MXD INFILL DEVELOPMENT CONCEPT PLAN

RESPONSE TO COMMENTS

CAMBRIDGE, MASSACHUSETTS
ISSUED NOVEMBER, 2016

IDCP RESPONSE TO COMMENTS

FIGURE R1.3.1

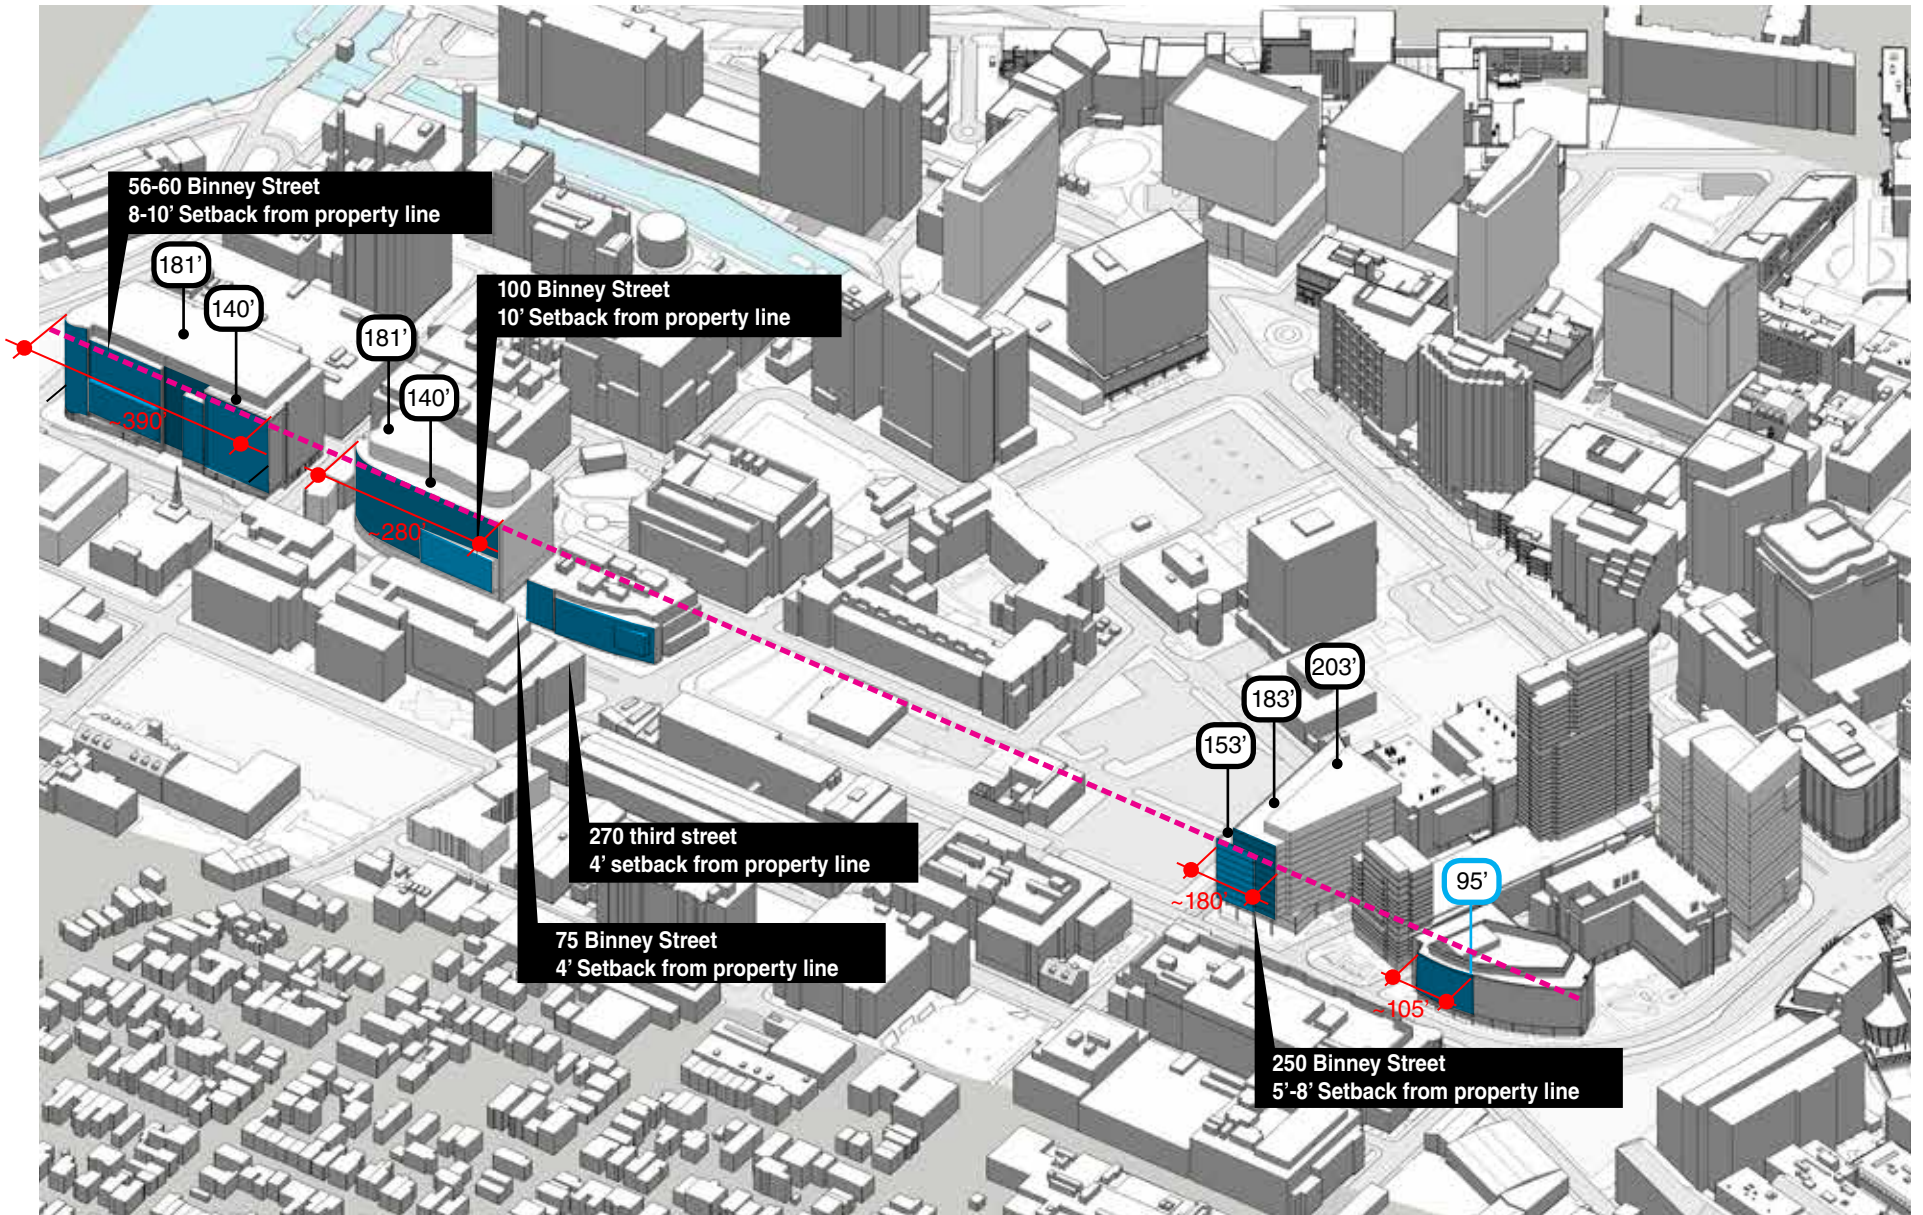
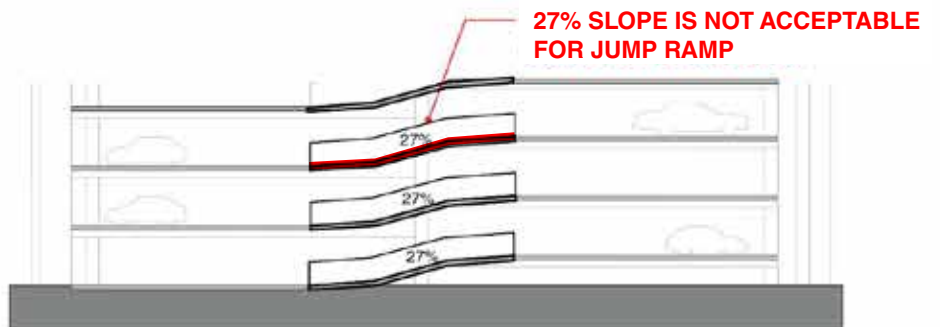
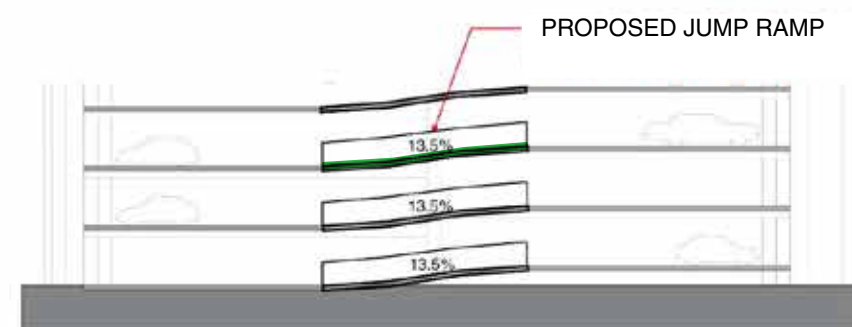
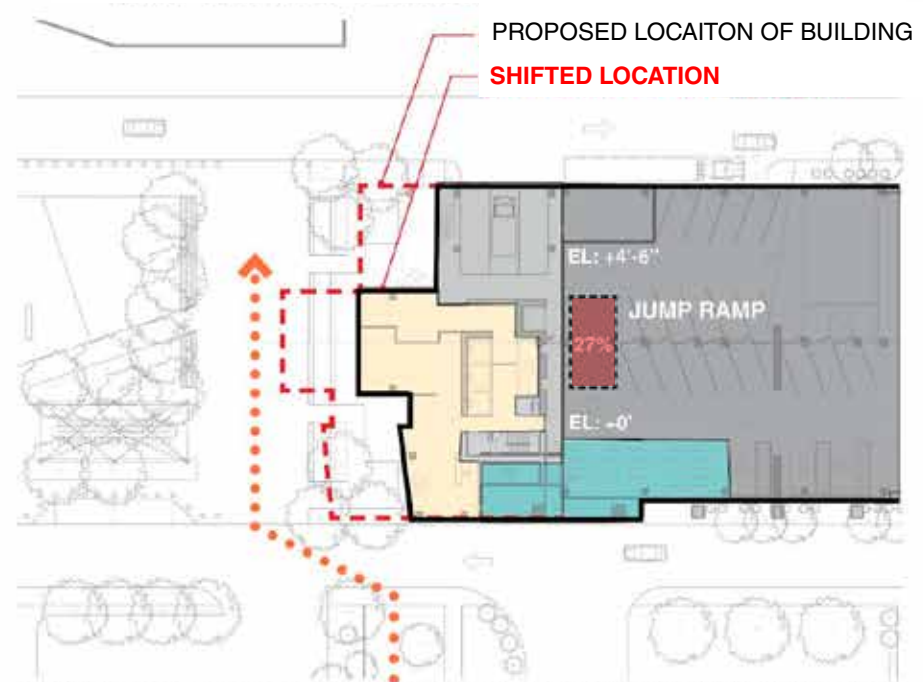
R1.3.1 BALCONIES: Applicant received three suggestions that the residential buildings include balconies. As indicated in the Residential Facades and Fenestration Guidelines, the residential buildings will provide balconies. The exact size and location will be included with the Design Review submission for the residential buildings. **FIG. R1.3.1** represents a conceptual study of the North Residential building with such proposed balconies in the slots per the design guidelines.

R1.3.4 CHARACTER OF BINNEY STREET FRONTAGE: The CRA staff has inquired about the relationship of parking within the Blue Garage to the Binney Street façade. **FIG. R1.3.1** represents a conceptual study of the proposed North Residential building with the parking masked in the same building fenestration. Screening elements will be consistent with the design guidelines for parking structure screening.

FIGURE R1.3.2B

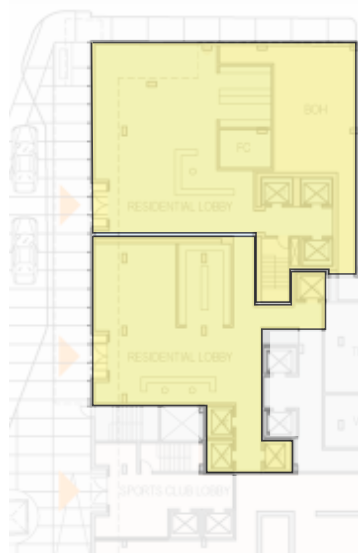
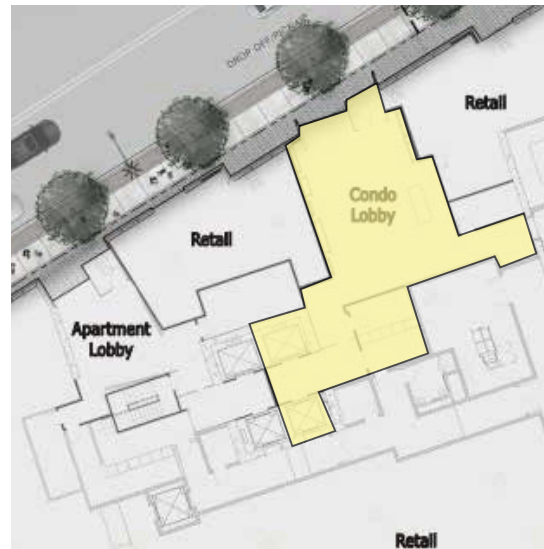
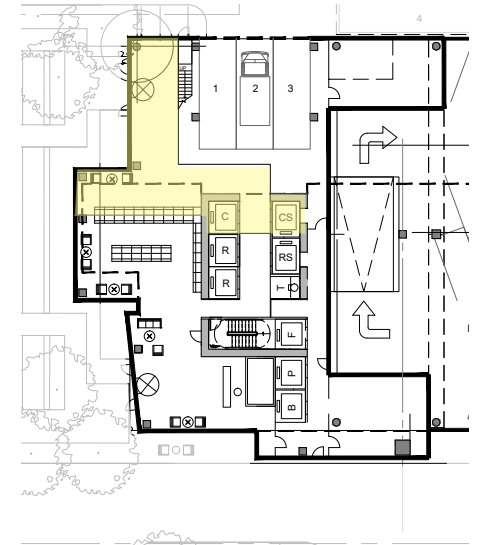
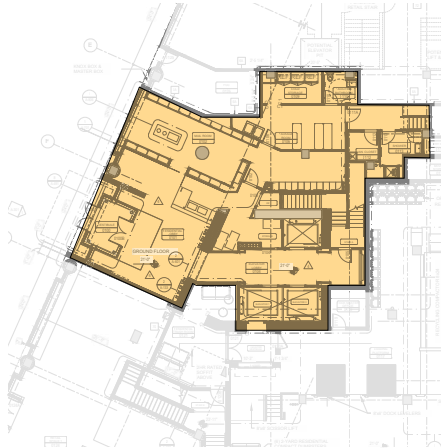
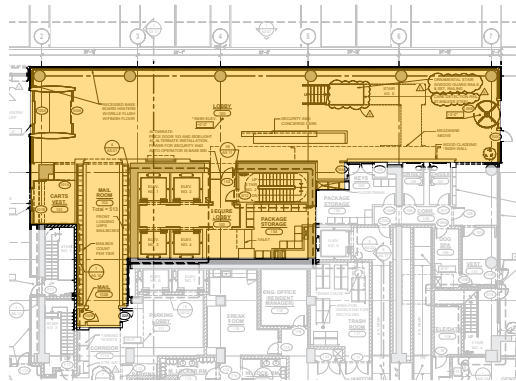
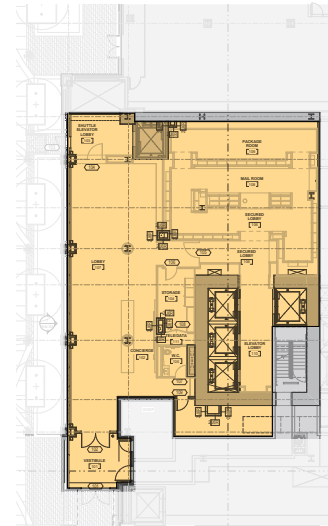
R1.3.2 RESIDENTIAL LOBBIES: Applicant received multiple questions and comments about the proposal for two, separate lobbies for the South Residential building. The space for ground floor use in the South Residential building is tightly constrained by the locations of parking circulation ramps required within the Blue Garage and shows as **FIG. R1.3.2** Further, the internal programming of the lobby, including USPS required package room dimensions and ADA access dimensions, results in a lobby size that is well below comparably sized lobby spaces as presented in **FIG. R1.3.2A** for a Condo Lobby comparison and **FIG. R1.3.2B** for a Rental Lobby comparison. The lobbies as designed are already constrained by dimensional requirements. Consolidation or further reduction from the proposed lobby size would call into question the viability of the residential project which is a critical element to creating a successful and dynamic mixed use development. A letter from our residential brokerage and marketing expert describing the necessity of the two-lobby proposal is included in the **Appendix: Exhibit A**. In addition, the lobbies are separated to allow for different maintenance and elevator service contracts between a condo home owners association and a multifamily property owner who often have different standards and requirements. For clarity, there is no distinction between affordable and market rate housing lobbies. The lobbies are distinguished by the 'for rent' housing and the 'for sale' housing, both of which contain an equal proportion of affordable and market rate units.

FIGURE R1.4.1

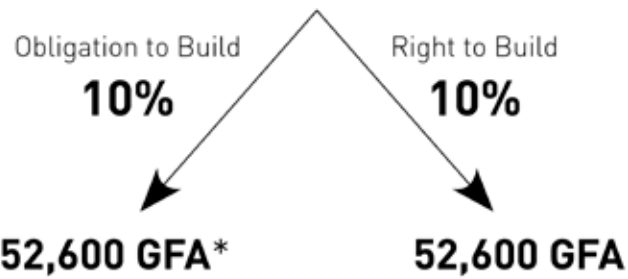
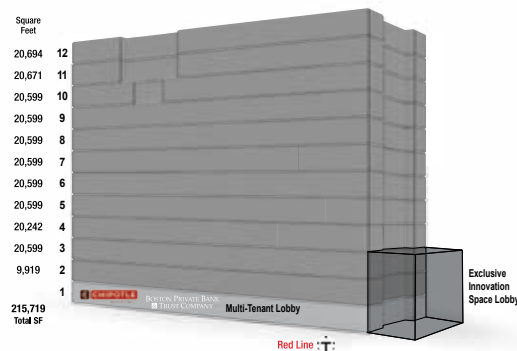
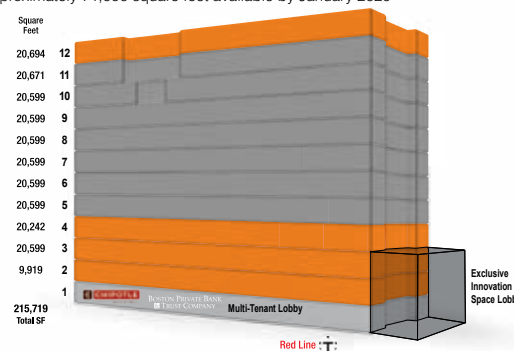
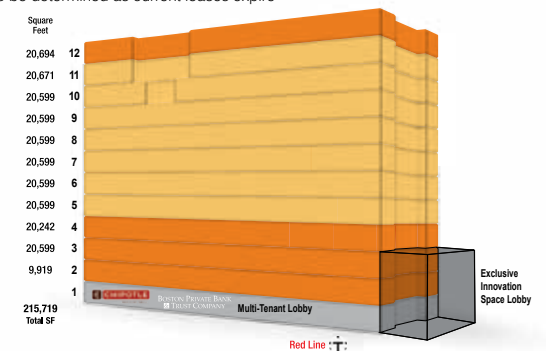
R1.4.1 CONCEPTUAL DESIGN AND OPERATIONAL DETAILS: CRA and CDD staff memos requested additional detail about the character and operation of the innovation space at 255 Main Street. Conceptual details on the character and phasing of the innovation space can be found in **FIG. R1.4.1- FIG. R1.4.4** Additional details about the entry design and interior character will be included as part of a separate Design Review Packages prepared specifically for the Innovation Space at 255 Main Street. Identity and entry opportunities are represented in **FIG. R1.4.4**
